Approved to Released 1/8/2008

QUESTION:

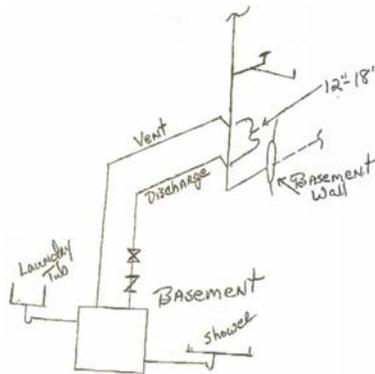
In drawing we have a sealed sump crock with fixtures dumping into it. Do to the difficulty of getting a vent above the flood rim of the highest fixture upstairs, is it legal to tie the vent back into a stack as shown?

"By consensus, it is the opinion of this committee that a vent cannot connect to a soil or waste pipe. It must extend at least 6" above the flood level rim of the highest trap or trapped fixture and it must tie into a vent pipe, not a soil or waste pipe. As shown in drawing, this is not a legal installation.
